Salton Sea Authority

Subject: Salton Sea Restoration Draft Programmatic EIR Comments

The Salton Sea Authority (SSA) respectfully submits its comments regarding the Salton Sea Ecosystem Restoration Draft Programmatic Environmental Impact Report (Draft PEIR).

Figure 1. Selenium levels near the mouth of the Whitewater River.

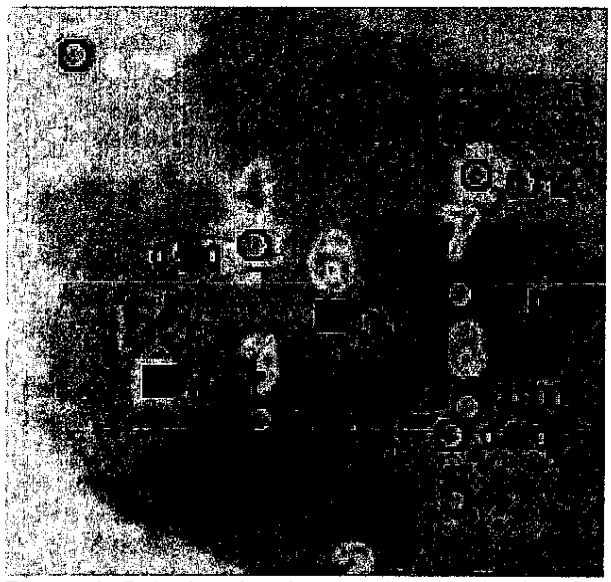
G-8. Selenium Levels at the Saline Habitat Complex (SHC) Proposed for the North Sea. Alternative 7 includes a 1,600-acre SHC at the mouth of the Whitewater River. Concerns have been expressed by the California Department of Fish and Game regarding high selenium levels in the sediments at this location, and that sediment-bound selenium would become salinated and thus bioavailable to benthic organisms, allowing selenium an entry-route into the food chain. A close examination of the selenium levels found within this proposed area show that only one sample location exists within this area, showing selenium levels from 0-15 cm depth to be 0.580 mg/kg dry weight (see Figure 1, below). This selenium level is within the range of levels found in the south end of the sea, in areas proposed for SHC in other alternatives. For example, Alternatives 1, 2, 4, 5, and 6 include SHC or SHC-like lakes over one sample location with a selenium result as high as 0.870 mg/kg dry weight. The selenium data map shows that local variations are substantial, with selenium levels of greater than 4.100 mg/kg showing up only one mile away from selenium levels of 0.710 (in the north sea, to the east of the proposed SHC). The SSA feels that without additional testing of the Whitewater delta area, that ruling out this area for a SHC is not justified by the limited and unreliable data available.

FIGURE 37. Concentration as a Function of Temperatures at Which the Compounds Precipitate From Solution.

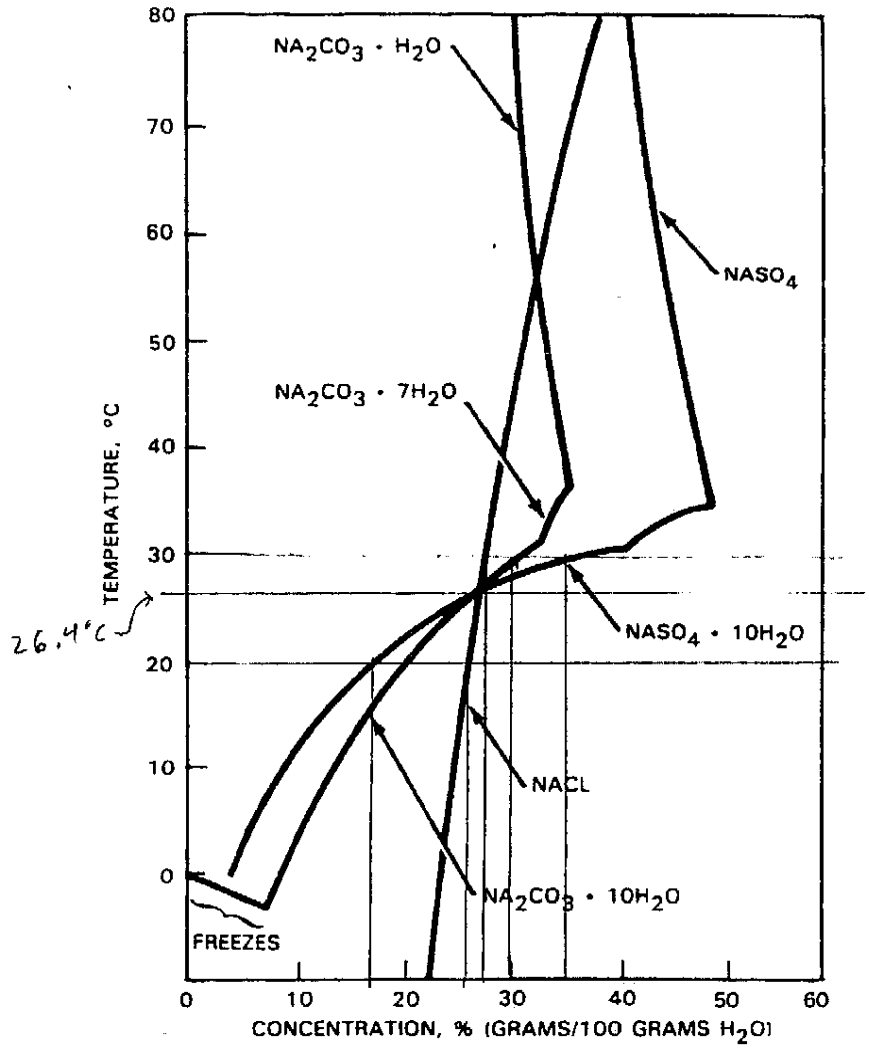
AQ-21 Attachment E9, Salt Crust formation mechanisms
The PEIR needs to provide a basic salt balance analysis for Salton Sea so that data such as Appendix D to Attachment E9 and the attached salt saturation curve sheet (at end of AQ comments) can be used to determine if the current development of evaporative salt deposits along the southern part of Salton Sea is simply the expected result of evaporation of typical Salton Sea waters at low temperatures or represents some other process. A salt balance analysis is also required to determine whether sodium chloride or sodium sulfate is likely to be the first salt to reach saturation and form precipitated deposits as water levels decline and salinity levels in the brine sink increase under the various alternatives. That information is critical to a

reasonable analysis at the programmatic level of whether or not areas around the brine sink would be emissive. (See salt saturation curve sheet at the end of these comments)
